TSB150153

Fault Code 3314, 3317, 3319, 3146 or 4518 Caused by Aftertreatment Exhaust Gas Temperature Sensor Malfunction

Figure 1, Date Code Location on the Aftertreatment Exhaust Gas Temperature Sensor

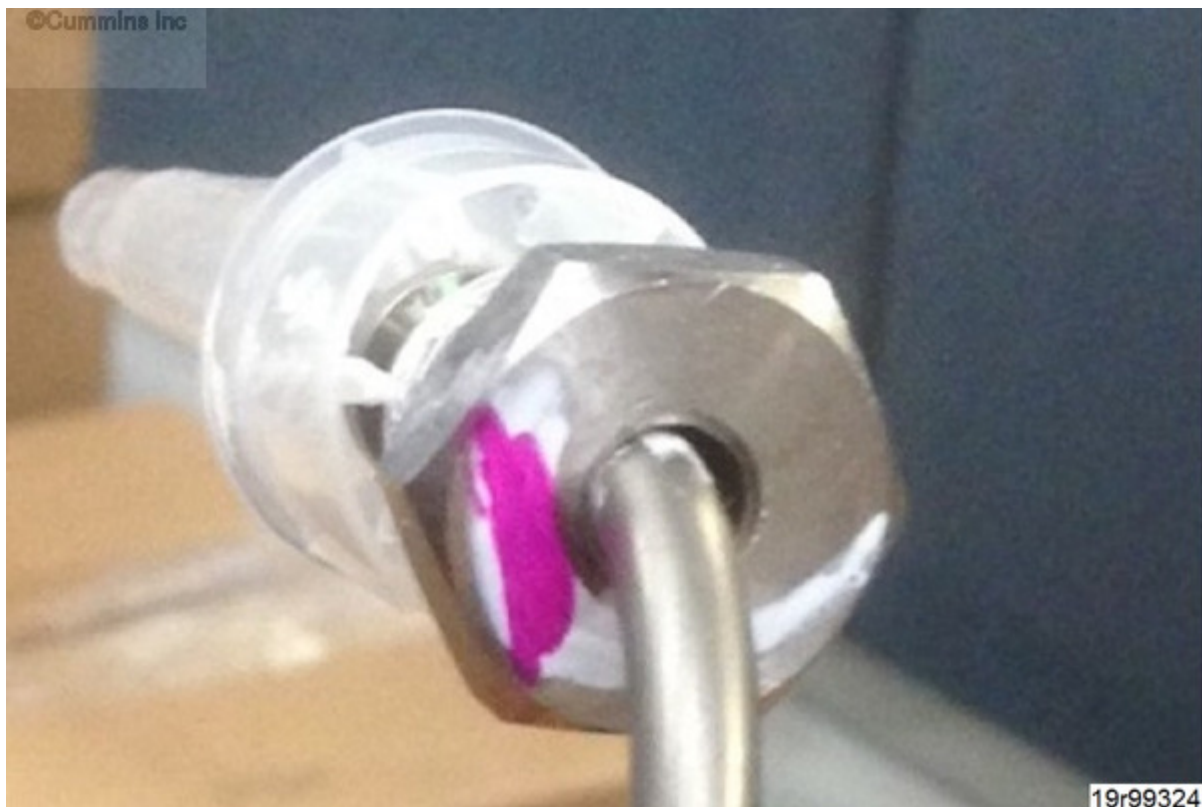
If the aftertreatment SCR exhaust gas temperature sensor or the aftertreatment DPF exhaust gas temperature sensor requires replacement, the new aftertreatment exhaust gas temperature sensor **must** be inspected prior to installation. See Table 1 below.

Table 1, Aftertreatment Exhaust Gas Temperature Sensor Inspection Criteria			
Part	Date Code On Sensor Body ¹	Marking on Hexagon Nuts ²	Action
Aftertreatment Exhaust Gas Temperature Sensor	20150730 and before	No marking	Do not use
	20150730 and before	White half circle and a pink line	OK for use
	20150731 and after	No marking or two parallel white bars	OK for use
¹ See Figure 1 Below. ² See Figure 2 Below.
